Location of Leased Premise **CALANDRA LOOKOUT** **MONTEREY COUNTY**
Agency Department of Forestry & Fire Protection **Real Property** #429

COMMUNICATIONS VAULT LEASE

AMENDMENT NO. One

Subject: CDF Radio Vault Space Application (TD-312) Modification
County of Monterey - L-0058
Calandra Lookout, Monterey County
CDF-VLT LCDF001154

PROPOSED FLOOR PLAN

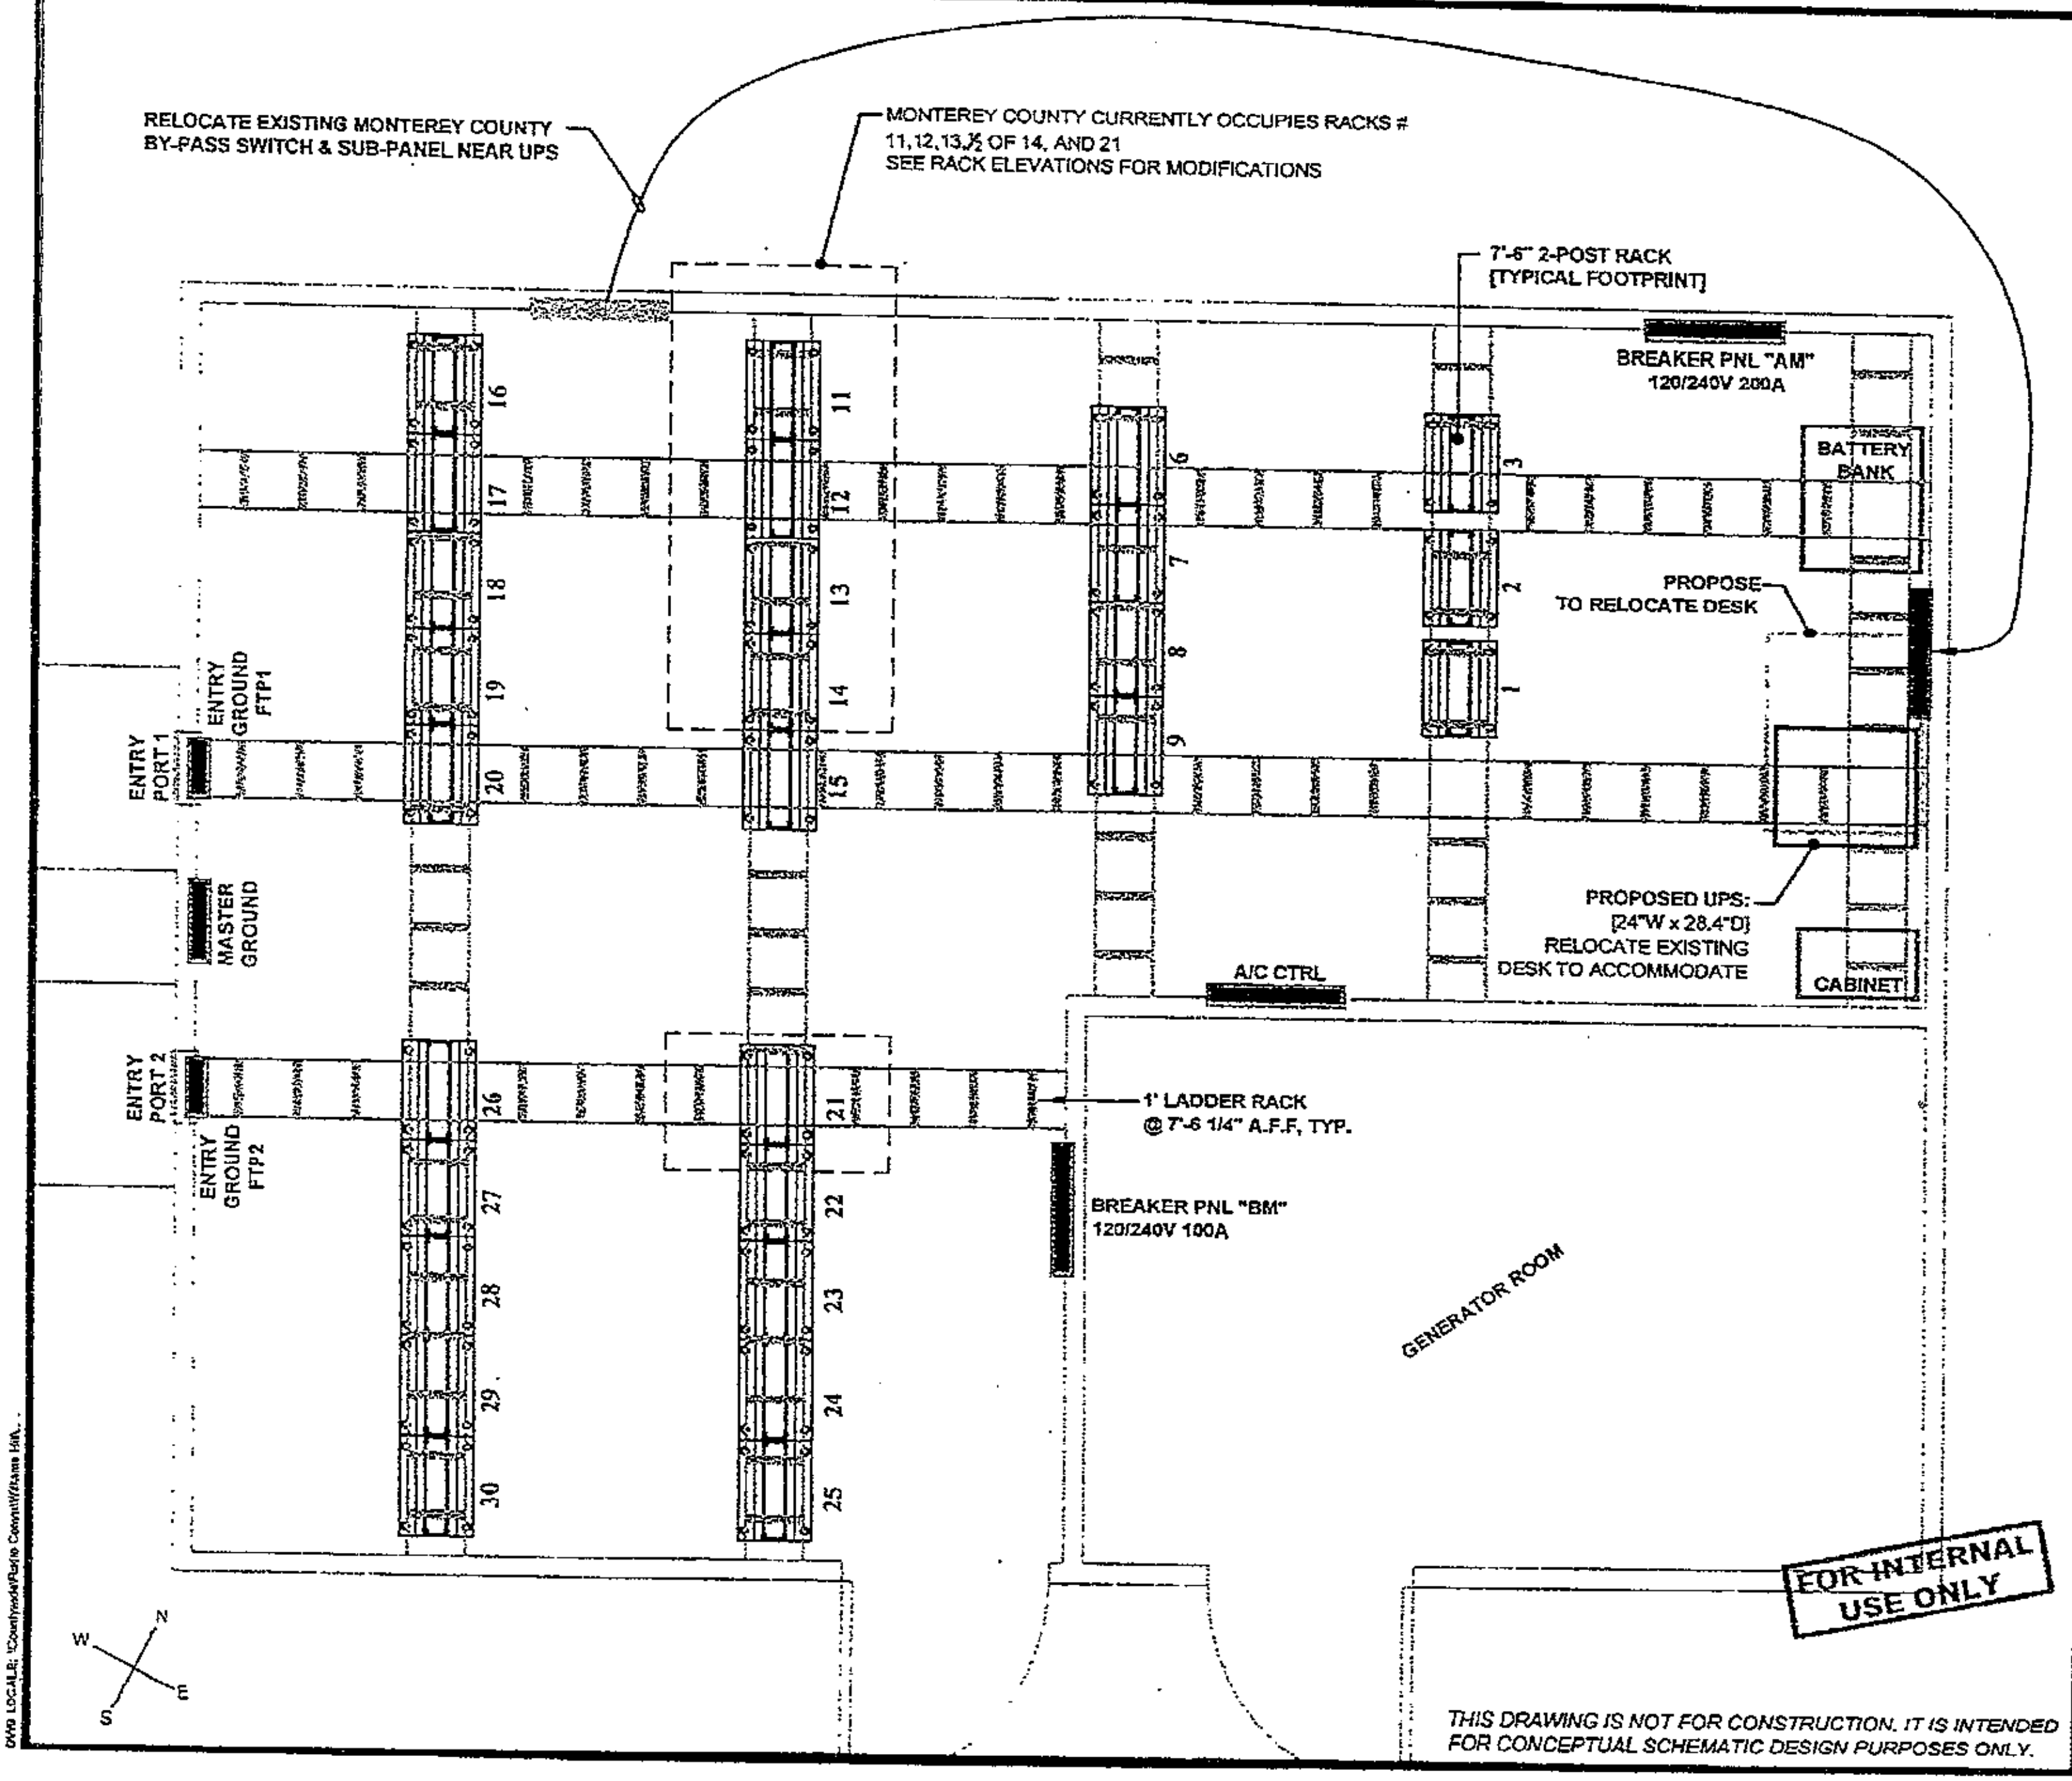
Replace/consolidate VHF Multicast equipment in Rack 11 and 12 with 700 Mhz Multicast (to occupy only Rack 12). Backfill Rack 11 with new County MST 800Mhz. Install UPS near existing State battery bank. Add UHF link and single VHF analog channel.

REV.	DATE	DESCRIPTION
-	4/24/12	ISSUE FOR SUBMITTAL
1	10/12/12	ADDED FREQ. TO DIGITAL
2	6/15/15	CHANGED MULTICAST SYSTEM FROM VHF TO 700MHz MULTICAST

SHEET TITLE
PROPOSED COUNTY RACK ELEVATIONS

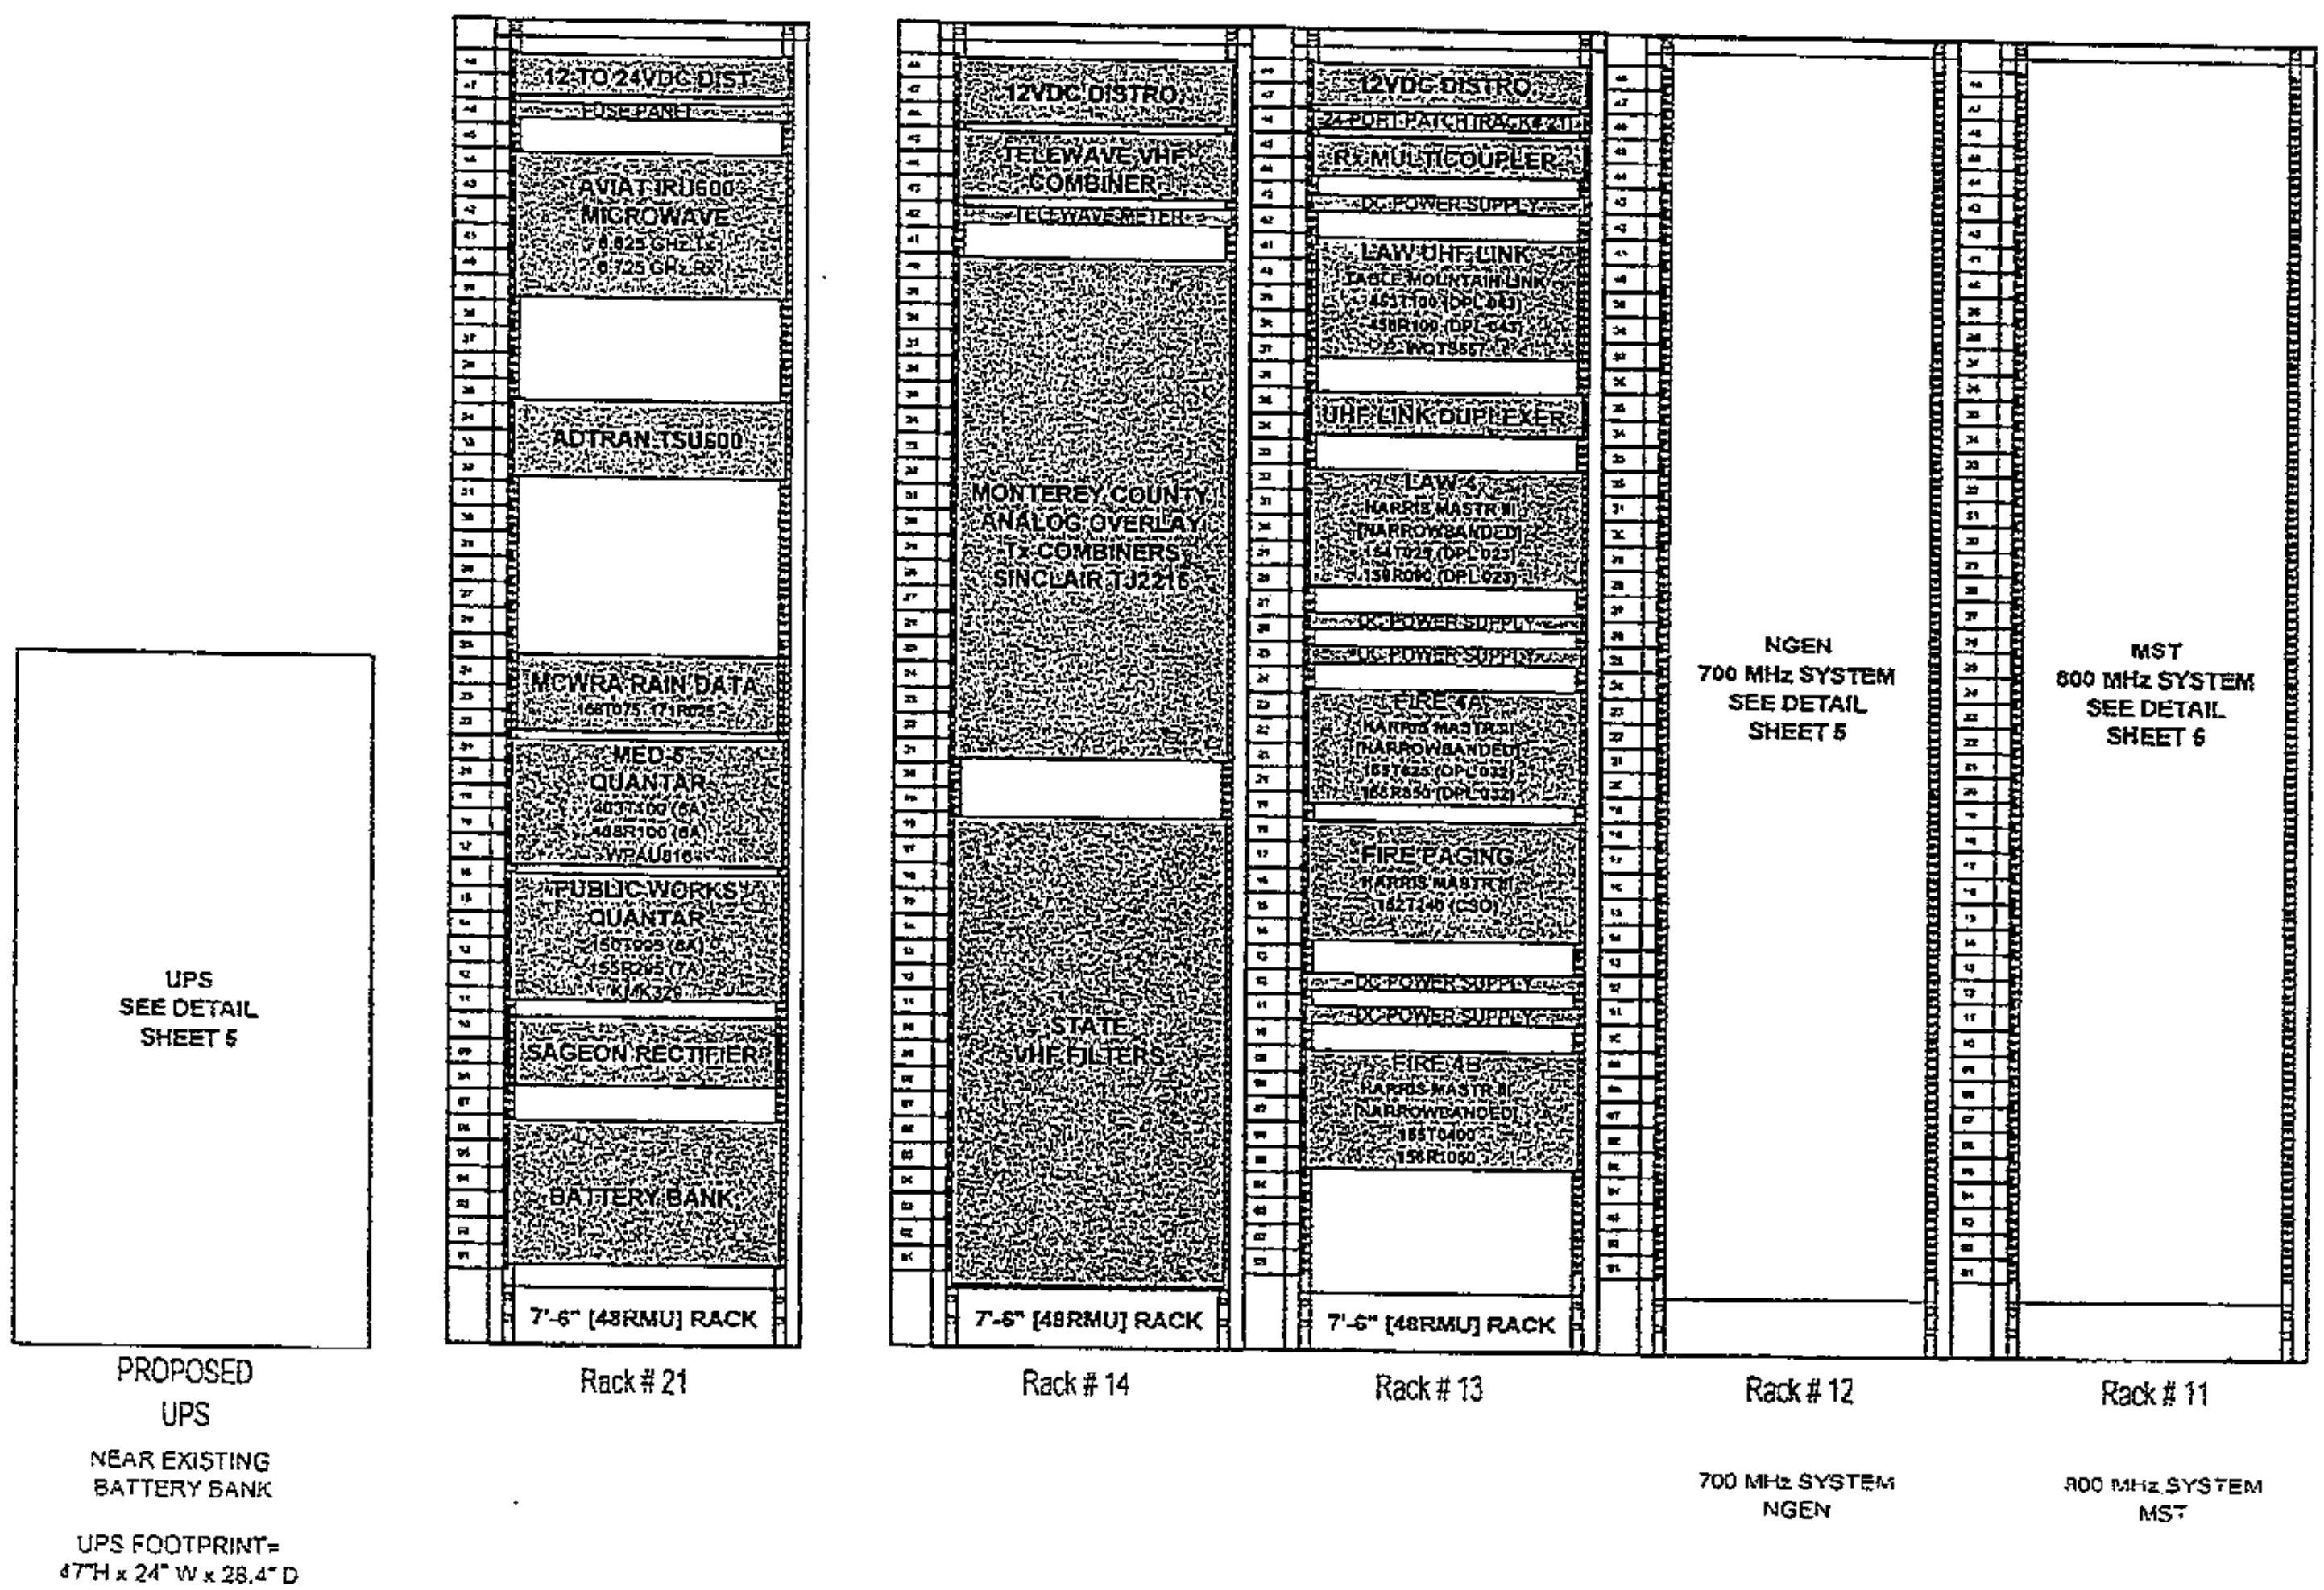
A technical analysis of the attached TD-312, California Department of Forestry and Fire Protection (CDF) Radio Vault Space Application for the County of Monterey has been completed. The County of Monterey is requesting to replace and consolidate VHF equipment in racks 11 and 12 with 700 MHz and 800 MHz, add a UHF link, VHF channel and a UPS at the Calandra Lookout.

REV.	DATE	DESCRIPTION
-	4/24/12	ISSUE FOR SUBMITTAL
1	10/12/12	ADDED FREQ. TO DIGITAL
2	9/15/15	CHANGED MULTICAST SYSTEM FROM VHF TO 700MHz MULTICAST
